1199 Superleggera Model Year 2014 1299 Superleggera Model Year 2017 1299 Panigale R Final Edition Model Year 2018 Panigale R Model Year 2015-2017 Safety Recall Bulletin SRV-RCL-19-002

Date: September 26, 2019

Based on continued quality tests and service reports, it was identified that the engine vapor breather system could operate incorrectly, with possible consequent leakage of engine oil from the Airbox breather tube.

All motorcycles involved in this Safety Recall Campaign will be upgraded by installing the kit part no.69929001A characterized by a new completely redesigned cyclone separator to prevent the operational issues.

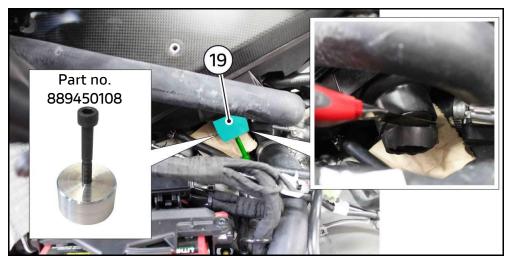
**23**. Take the tool part no.889450108, insert the buffer in the cyclone **hose (19)** driving it fully home and remove the excessive section of hose using a cutter.

<u>During the trimming operation, protect the surrounding components around the cyclone hose to avoid damaging the coolant hoses</u>

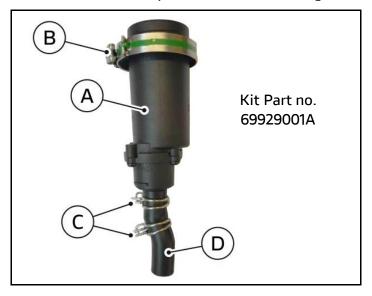
Check that the remaining length of the cyclone **hose (19)** is equal to approx. 30 mm and remove both the protection used and the tool part no.889450108.

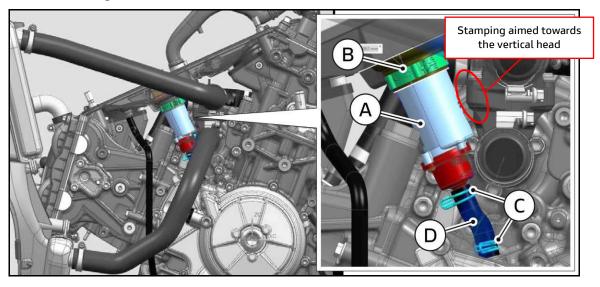
**24**. Take the kit part no.69929001A and assemble the **cyclone separator (A)**, the **click clamp (B)**, the **rubber hose (D)** and the **2 clamps (C)** as shown in the figure
